Technical Bulletin

Bulletin Number: 396 Revision Number: R-02

SUBJECT: VALIDATOR SHIELD FOR ARDAC USA15

MODELS AFFECTED: Dr. Pepper D3 79" High Venders
Seven Up B7 79" High Venders

Validator Shield D3
453,010,15x.x3
Figure 1

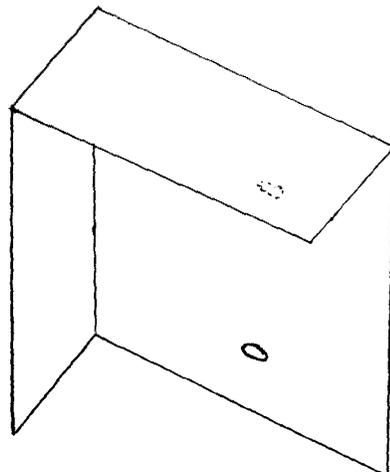
REASON: To provide a "shield" which, when installed, prevents access to the bill validator via the sign face.

ORDER: **For Dr. Pepper D3 79" Venders**
1 - 453,010,15x.x3 Validator Shield
7 - 900,301,56x.x1 Screw, Phil Pan #8-32x³/₈

**Inside Main Door - Top Left
Figure 3**

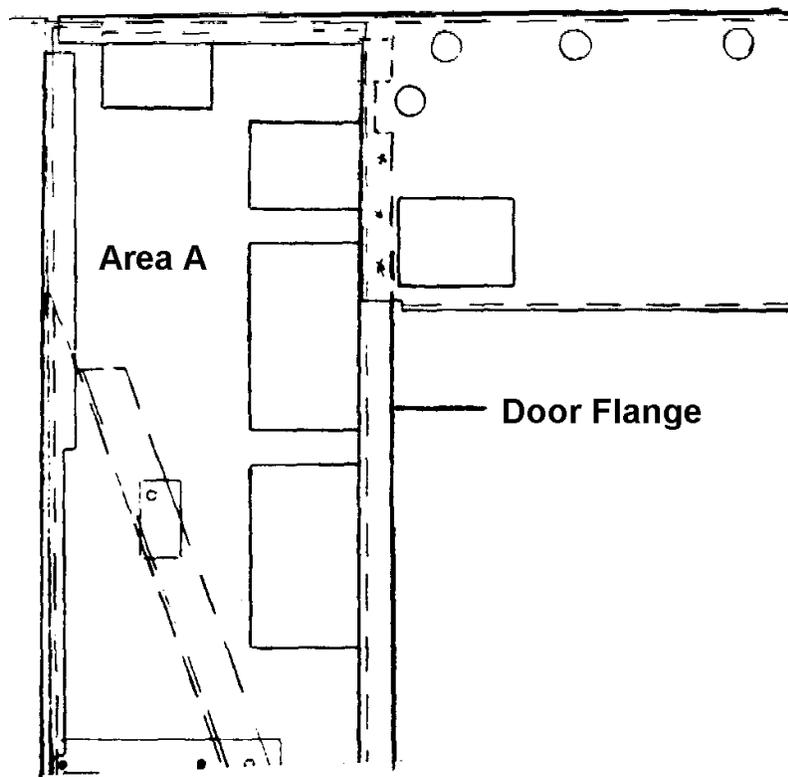
To Install in Dr. Pepper D3:

1. Hold the shield in position as shown in figure 3.
2. Insert the shield in Area "A", figure 3 (shield all the way to the top) with the shield's flange extending over the main door flange.
3. Use the shield as a template and mark the seven mounting holes.
4. Drill $\frac{9}{64}$ " diameter holes at the seven positions marked in step 3.
5. Place validator shield back in Area "A" and secure with the phil pan screws.

**Inside Main Door - Top Right
Figure 4**

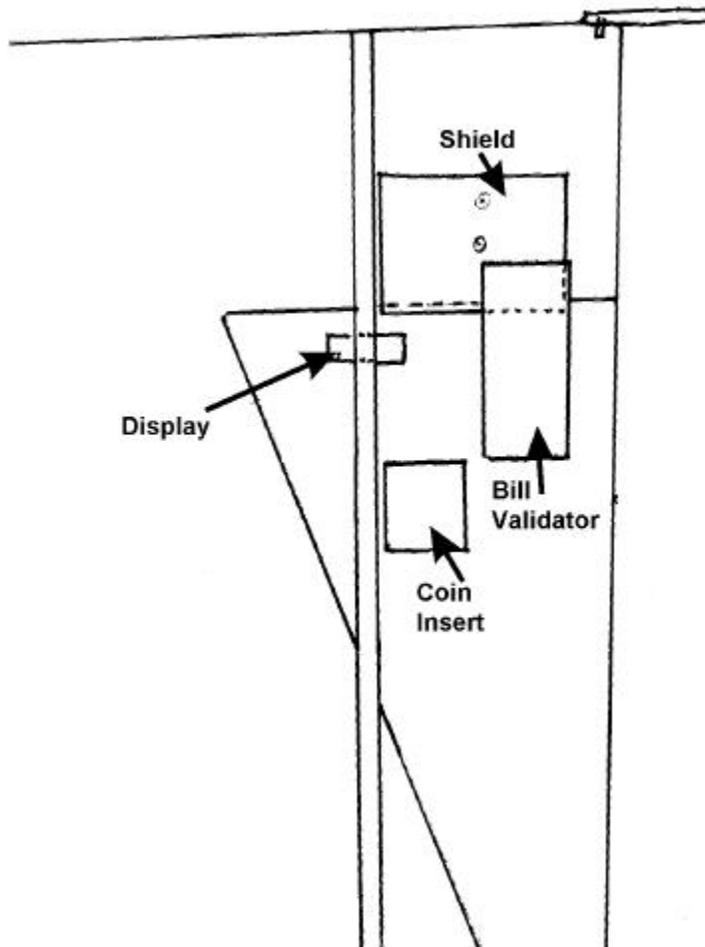
To Install In 7UP B7:

1. Hold the shield in position as shown in figure 4.
2. Insert the shield in the bulkhead above the validator opening. Shield blocks access from sign area through lighting holes over to top of validator.
3. With the shield in position secure it with two self-drilling screws (900,301,65x.x1).
